WILLIAMSON COUNTY, TEXAS  
CHANGE ORDER NUMBER: 12

Project: 10WC817  
Roadway: US 79 Section 3  
CSJ Number: 0204-02-027, etc

**US 79 Section 3  
Williamson County Project No. 10WC817**

**Change Order No. 12**

Texas Department of Transportation  
2010 T&B  
US 79 SECTION 3  
PROPOSED  
TYPICAL SECTIONS

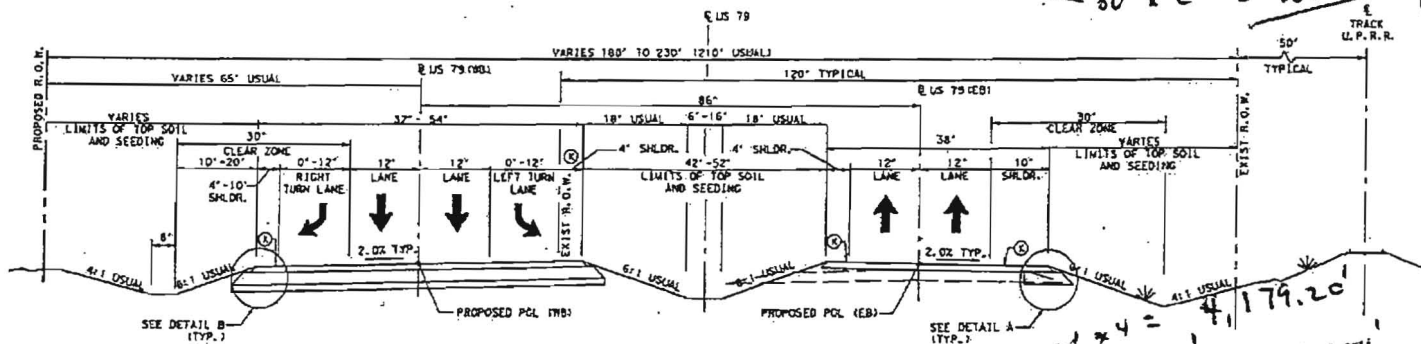
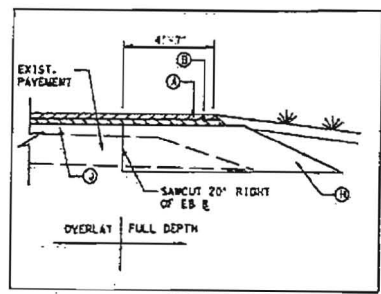
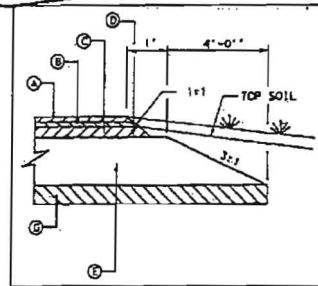
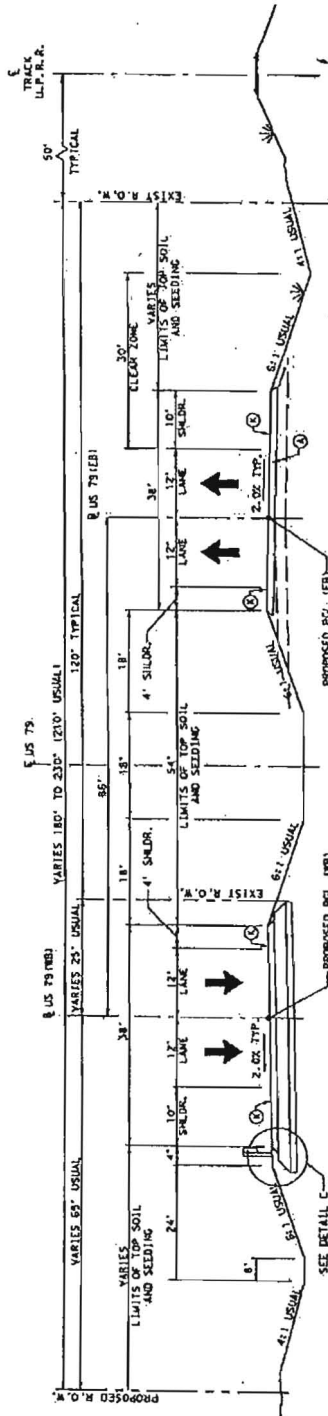
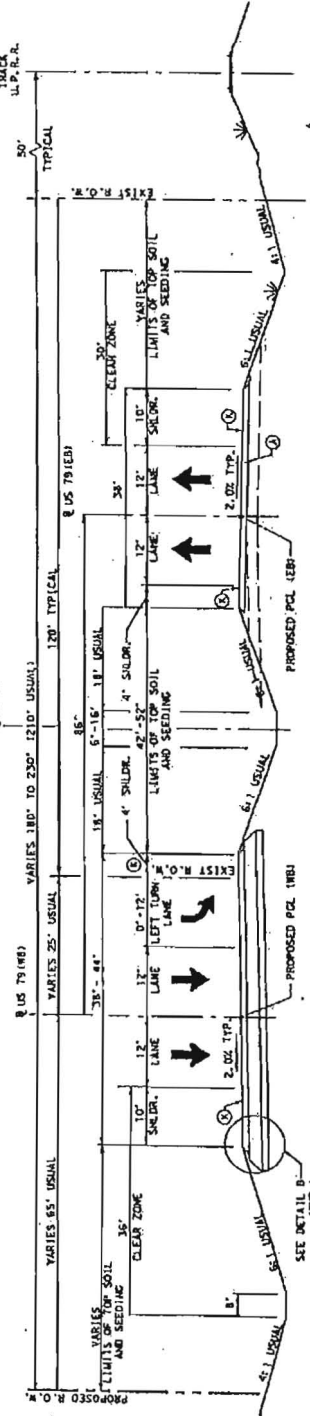
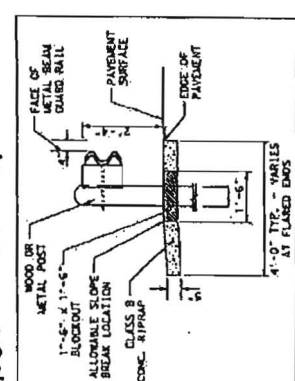
$$\begin{aligned} 86' \times 2 &= 172' \\ 80' \times 2 &= 160' \\ 80' \times 2 &= 160' \\ 80' \times 2 &= 160' \end{aligned}$$

$$\begin{aligned} 1044.80' \times 4 &= 4,179.20' \\ 1101.00' \times 4 &= 4,404' \end{aligned}$$

SUB TOTAL: 2,797.60'  
9,235.20'

1812.52' X 4 = 7,250.08'  
 1660.16' X 4 = 6,640.64'  
 329.35' X 4 = 1,317.20'  
 300.67' X 4 = 1,202.68'

1051.20' X 4 = 4,204.80'  
 1051.00' X 4 = 4,204.00'

WHITE =  $29,834.38'$   
YELLOW =  $29,834.38' - 652' = 29,182.38'$

US 79 SECTION 3  
PROPOSED  
TYPICAL SECTIONS

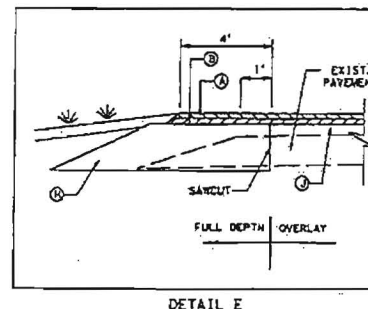
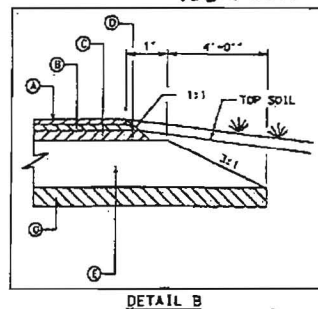
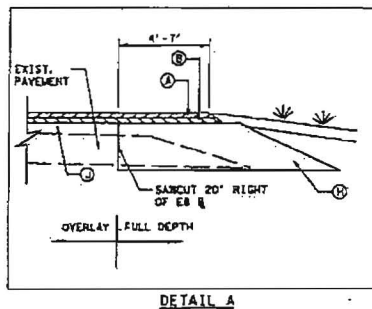
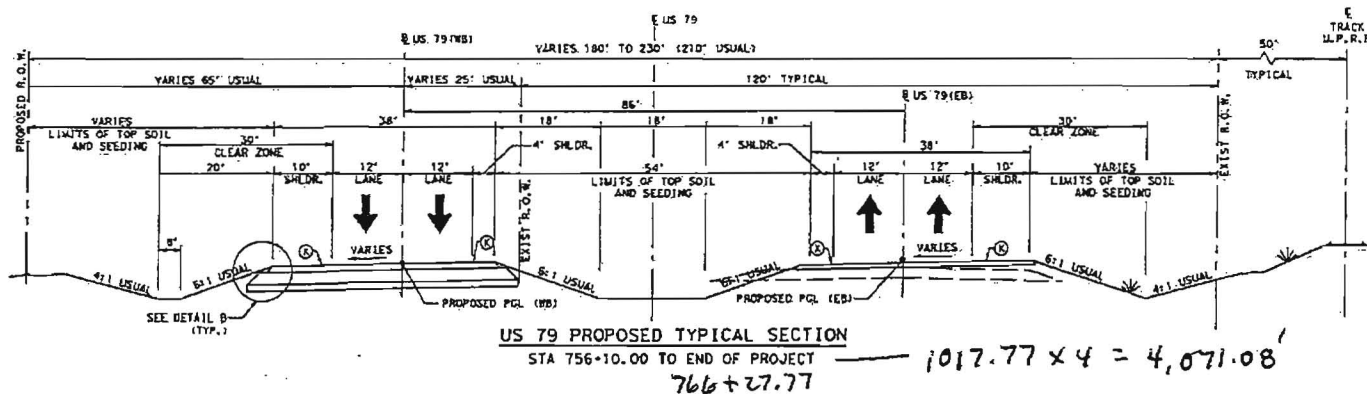
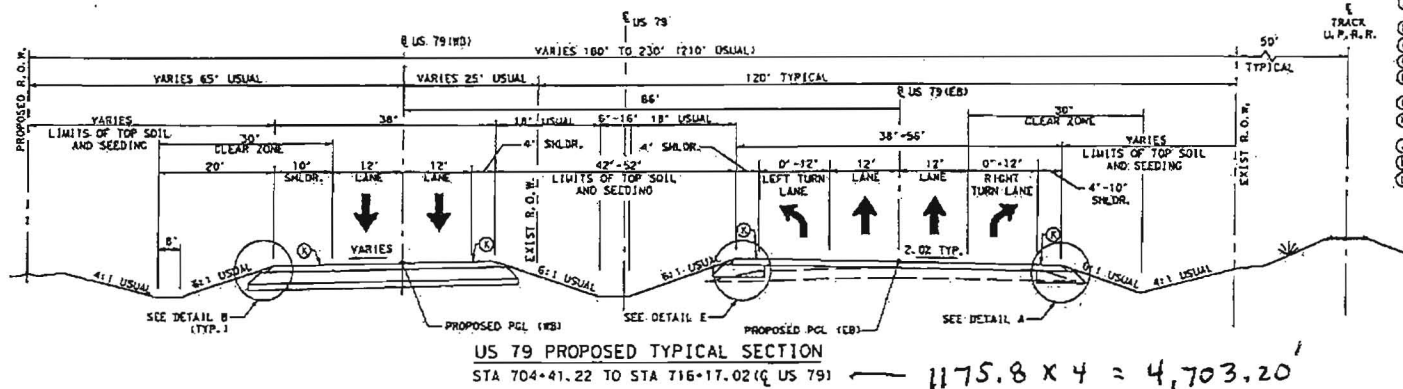
SUB TOTAL:  $8,774.28'$
